SECTION 00 9117
ADDENDUM NUMBER 7

DATE: August 23, 2016

**RSMP Phase 2A
James Monroe High School**

DRAWING REFERENCE NUMBER(S): 1/S011
 DRAWING NUMBER: ADD7-S-01

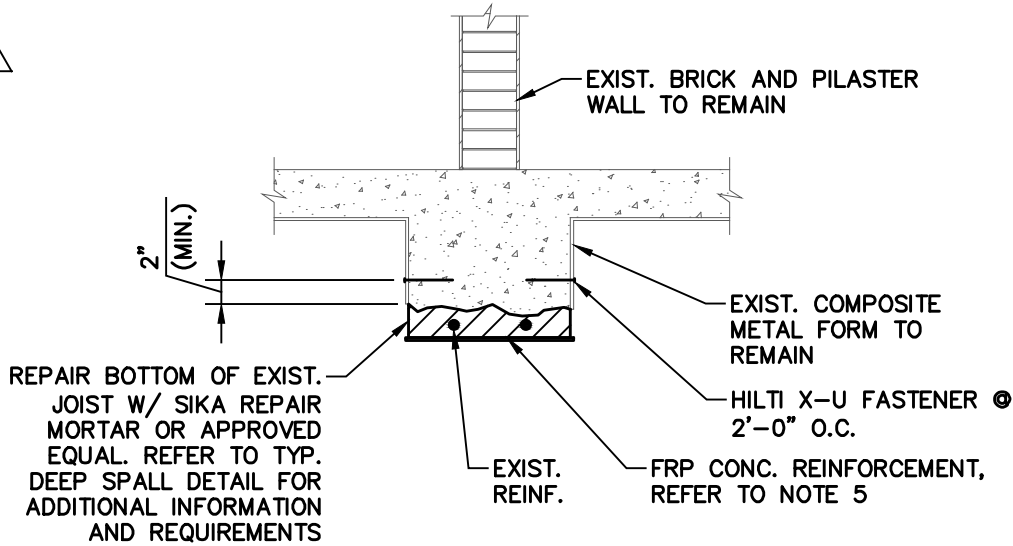
- A. Reinforcement note revised where existing concrete joists support existing wall to remain. Refer to attached sketches ADD7-S-01, ADD7-S-02, and ADDSK-A-15.

1. REMOVE EXIST. COMPOSITE METAL FORM ONLY TO THE EXTENT REQUIRED TO REPAIR BOTTOM OF JOIST TO SOUND CONCRETE AND PLACE FRP REINFORCEMENT.
2. PROVIDE FRP REINFORCEMENT EQUAL TO (4)-#8 BARS. FRP REFERS TO CARBON FIBER REINFORCED POLYMER REINFORCEMENT. REFER TO SPECIFICATION SECTION 03 01 32.

3. TYPICAL JOIST AT EXIST. BRICK WALL SHOWN, SIZE VARIES.
4. PROPOSED FLOOR INFILL NOT SHOWN FOR CLARITY.
5. DETAIL IS SIMILAR FOR JOIST REPAIR. FRP NOT REQUIRED AT JOISTS NOT SUPPORTING BRICK AND PLASTER WALLS ABOVE.

1 CLASSROOM 106 RETURN DUCT PLAN
 M133 SCALE: 1/8" = 1'-0"

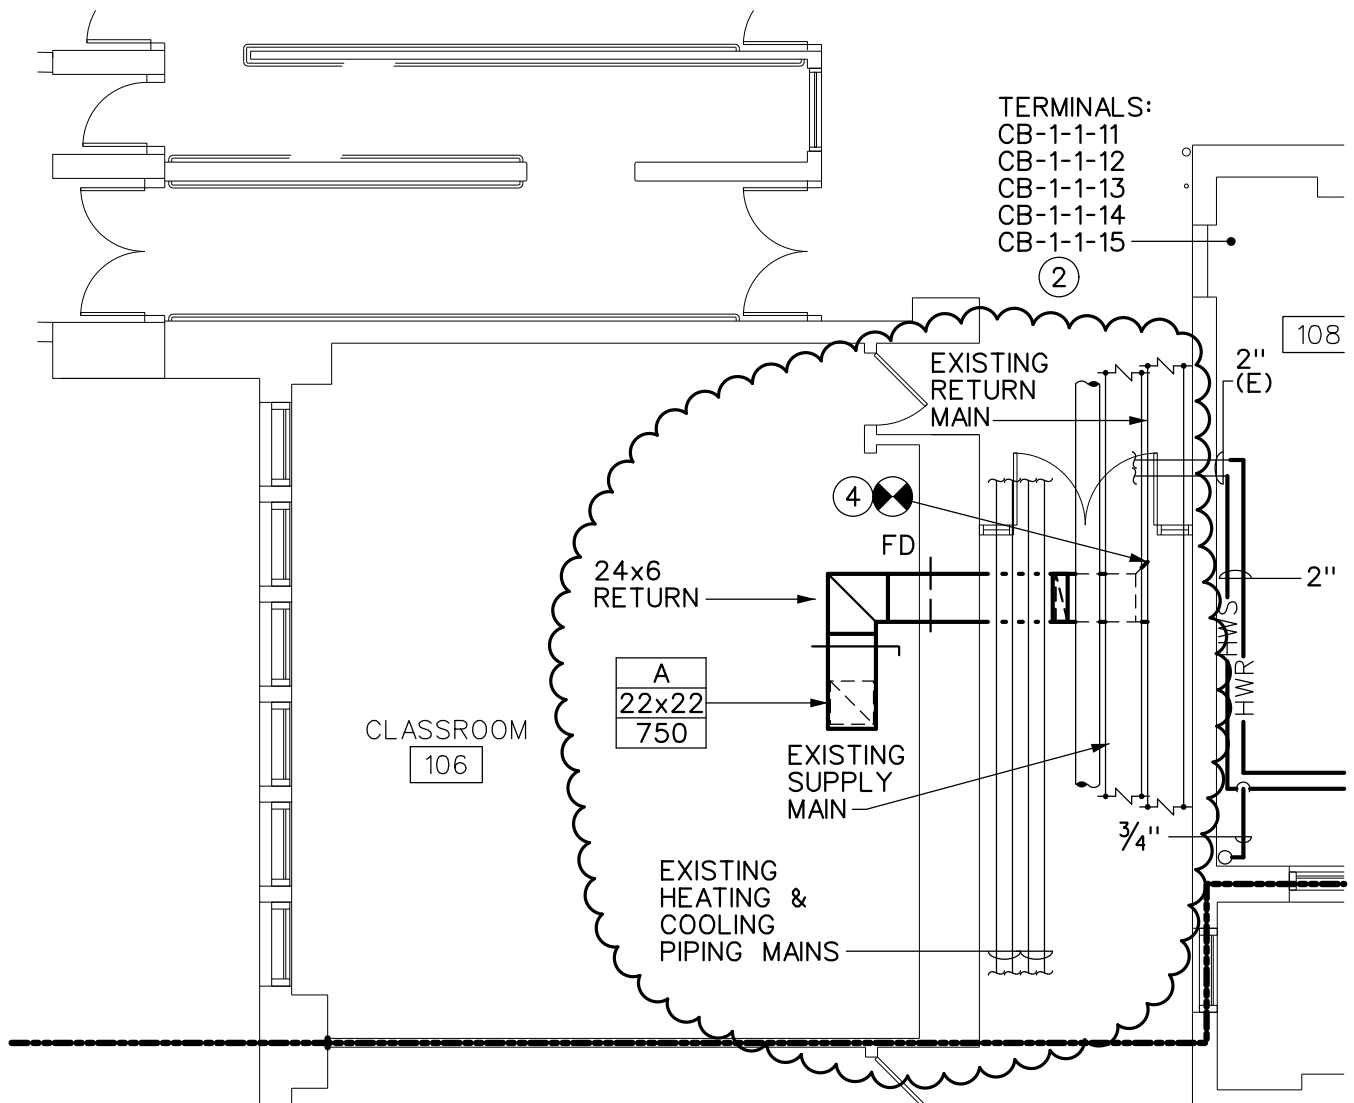
- A. Add the return ductwork system to Classroom 106 as indicated on the attached sketch ADD7-M01.

- A. THIS SKETCH IDENTIFIES THE SCOPE OF WORK TO ADD A RETURN AIR SYSTEM TO CLASSROOM 106.

1 CORR BC-3A VENTILATION PLAN
 M113 SCALE: 1/8" = 1'-0"

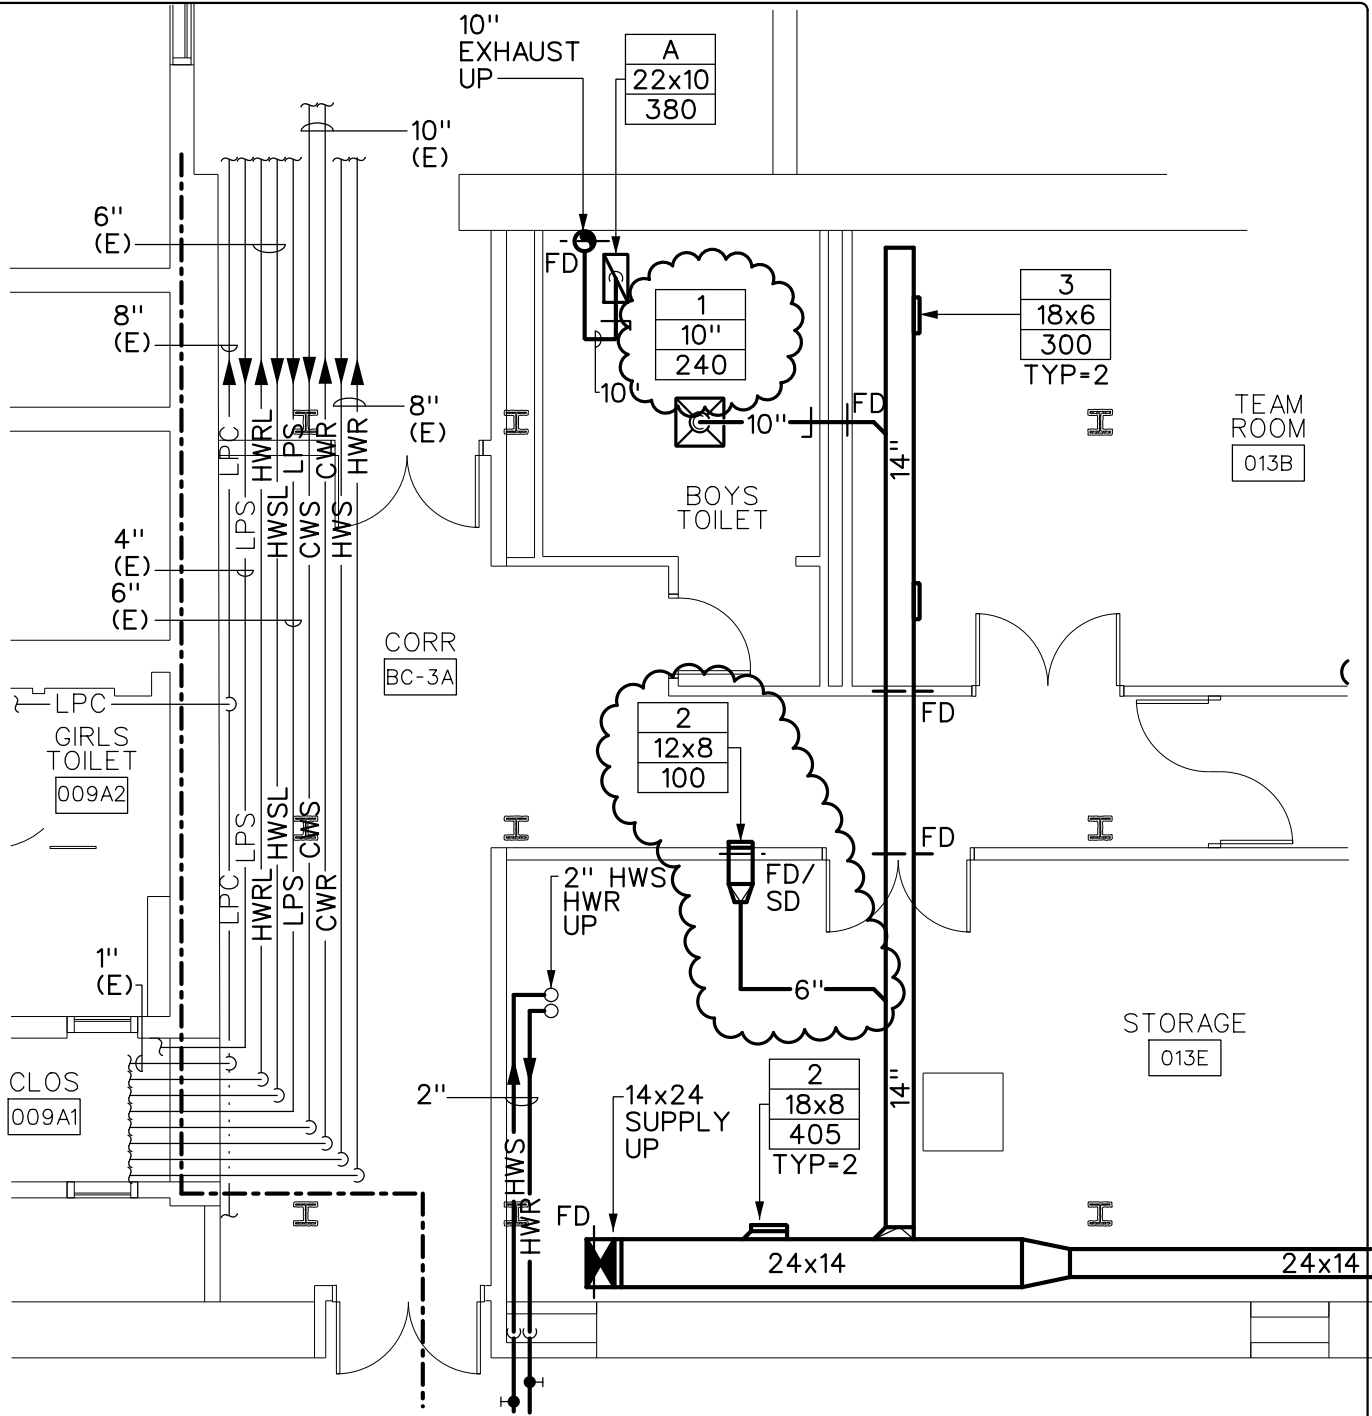
- A. Add the additional ventilation to Corridor BC-3A and revise the supply airflow rate to Boys Toilet as indicated on the attached sketch ADD7-M02.

- A. THIS SKETCH IDENTIFIES THE WORK TO PROVIDE VENTILATION TO CORRIDOR BC-3A.

**FIRST FLOOR
 REFLECTED CEILING
 PLAN**

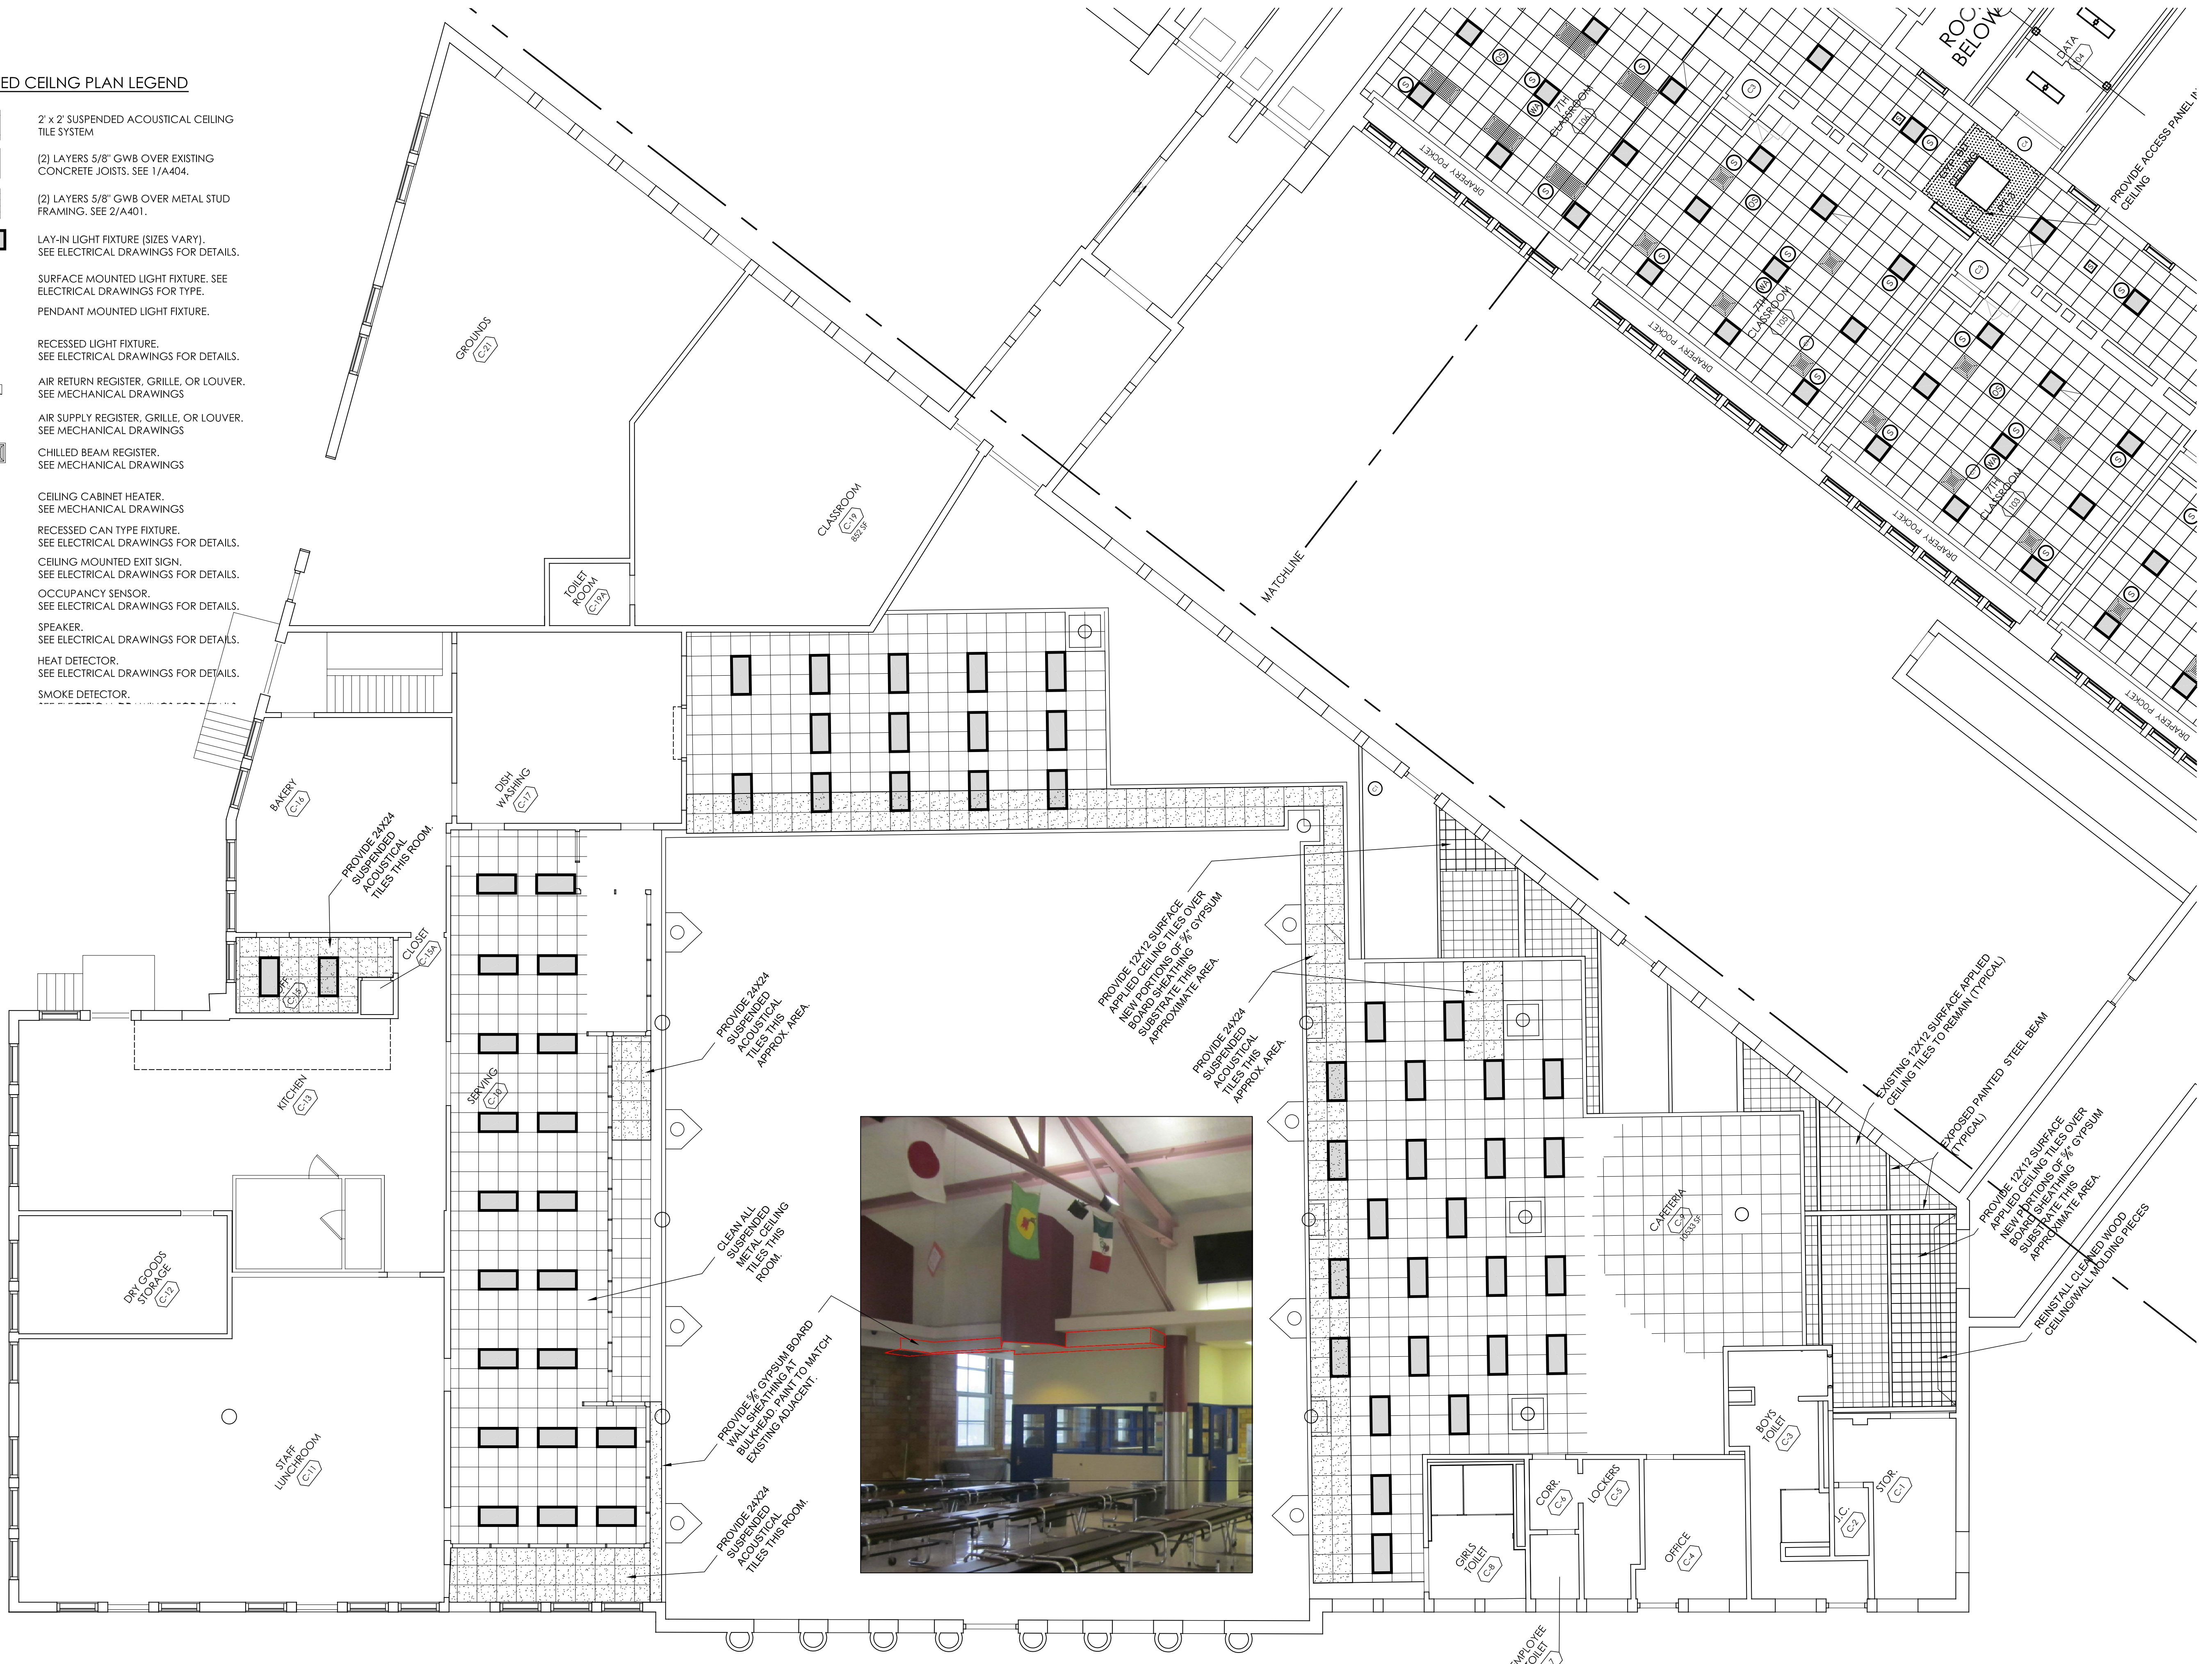
A410 – FIRST FLOOR REFLECTED CEILING PLAN

- A. Replace drawing in its entirety with the drawing attached.

JOB NO.	1522
SCALE	1/8" = 1"
DATE	JULY 1, 2016
DRAWN BY	JC, ME
CHECKED BY	CJ
REVISIONS	
8.23.16 Addendum No 7: Added Cafeteria ceiling work
